Access Compliance Report Public Rights-of-Way (Pedestrian Signals)

Main Street: **IRVINE_BLVD** Cross Street: **HOLT_AVE** Location: **NW**

ADA ID: **SGRK211011141727** Signal Type: **One Push Button-APS** Overall Compliance: **No** Severity Scores: **BTN 1: 25** **BTN 2: N/A** **No BTN: N/A**

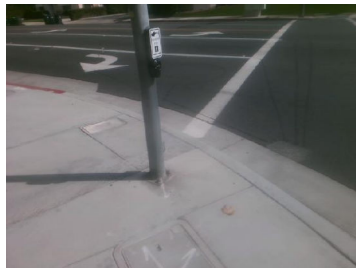
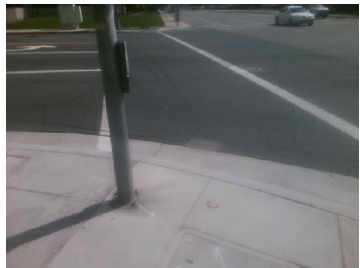
OC Std/PROW: **R404.2, R404.3**

Possible Solutions: Remove and Replace Clear Space.
